### AMBLER BOROUGH PLANNING COMMISSION

1. Review "Ambler Crossings Phase II (South Chestnut Street) preliminary and final land development application proposing construction of a 92-unit residential apartment building with associated driveways, parking, utilities, and stormwater management design. *Motion Requested*

Development Name: Ambler Crossings - Phase II

O:\1845 - Ambler Crossings Phase II\Outbound\Borough Response Letter 2026-03-20.docx

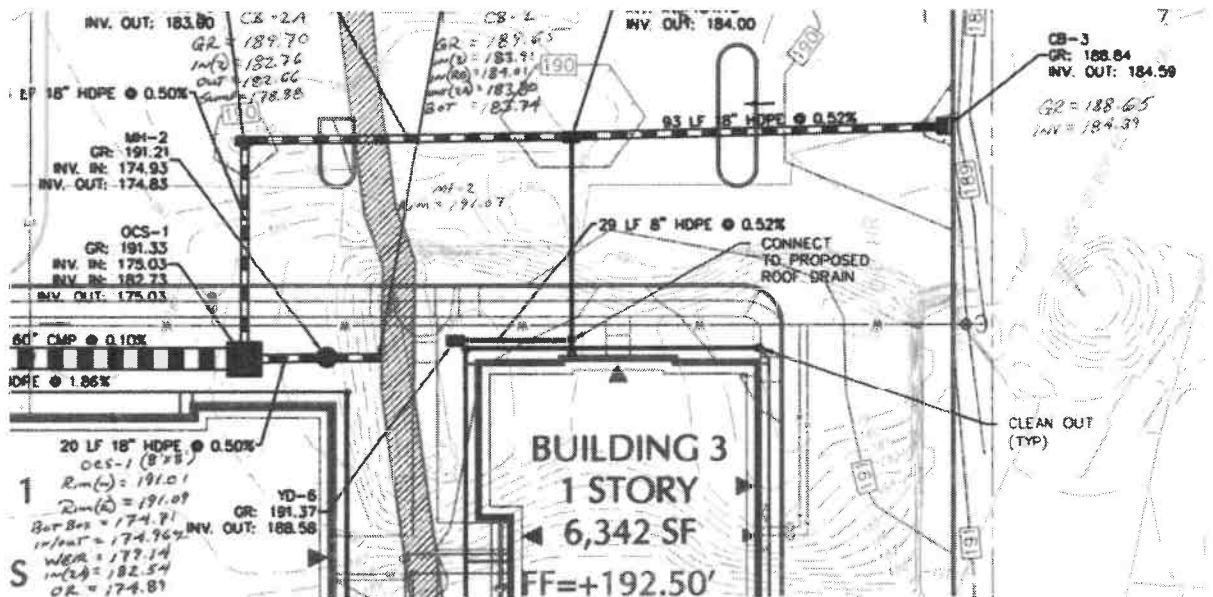
**Response: On Plan Sheet C1.0, note 8 is provided.**
34. The storm sewer connection at existing Crossings Phase I inlet CB-3 conveys stormwater to the Phase I UG Detention Basin-1. It is noted that the Phase I system was designed to contain the entire 24-hour, 100-year design storm volume due to tailwater and capacity constraints within the existing stone arch culvert. The stormwater management report shall include analysis demonstrating that the proposed Phase II system will function as intended and not impact the function of the Phase 1 system or the existing stone arch culvert in any way. Either the proposed design shall account for maximum tailwater conditions at the Phase I UG Detention Basin-1 or the proposed system shall be sized to contain the 100-year storm volume.

**Response: While we agree with the consideration of tailwater from the Phase I basin and stone arch culvert system, we do not believe that tailwater affects the proposed Phase II basin. The below screenshot depicts an as-built markup of the Phase I site:**
